SPARC® Enterprise M4000/M5000 Servers Product Notes

For XCP version 1041

About the interference of nut

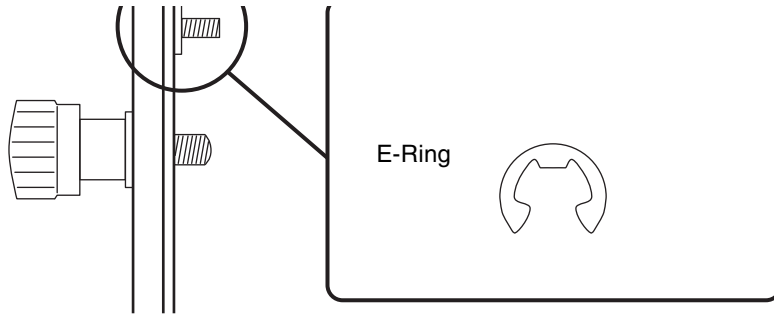
When you mount the SPARC Enterprise M4000 or M5000 server on the 19-inch rack, as you insert it all the way seated in the rack, the nut anchoring the bezel may interfere with the rack column and the server may fail to be seated correctly.

In such a case, please replace the bezel anchoring nut and ring with the E-Ring.

1. Remove the interfering bezel anchoring nut and ring.

2. In place of the removed nut and ring, attach the E-Ring, included in the rack mount kit.

3. Insert the server all the way seated in the rack, to lock it in place.
